## **SECTION 4.55(1A) MODIFICATION APPLICATION – SSD-9831 MOD 2 WESTERN SYDNEY UNIVERSITY BANKSTOWN CITY CAMPUS**

This Section 4.55(1A) Modification Application has been prepared by Urbis Pty Ltd (Urbis) on behalf of Western Sydney University (the Applicant) to amend SSD-9831 which applies to the Western Sydney University (WSU) Bankstown City Campus at 74 Rickard Road, Bankstown.

- A modification to increase the width of the approved signage zone on the southern façade of the building from 20.7m to 25.6m.

Figure 2: Comparison of approved v proposed sky signage zone on southern elevation

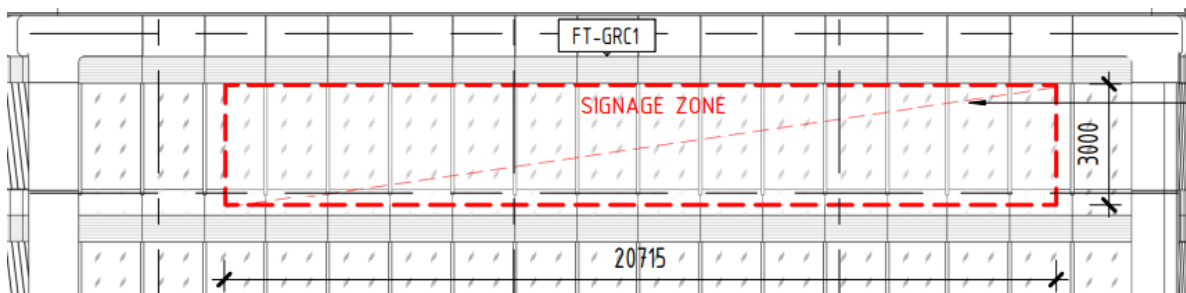
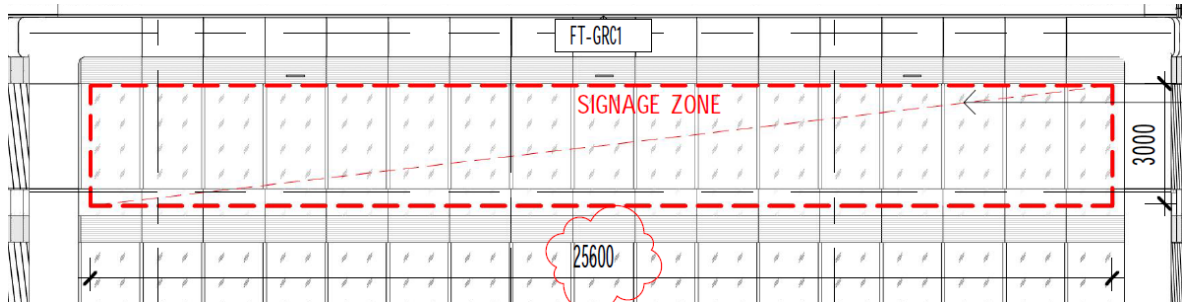
- Increase in width of the approved signage zone on the southern façade zone of the building from 20.7m to 25.6m shown in **Figure 2** and **Figure 3**.

Drawing No.	Rev	Name of Plan	Date
DA40-03	6	Building Elevations – South	17/12/2020
	<b>7</b>		<b>27/01/2022</b>
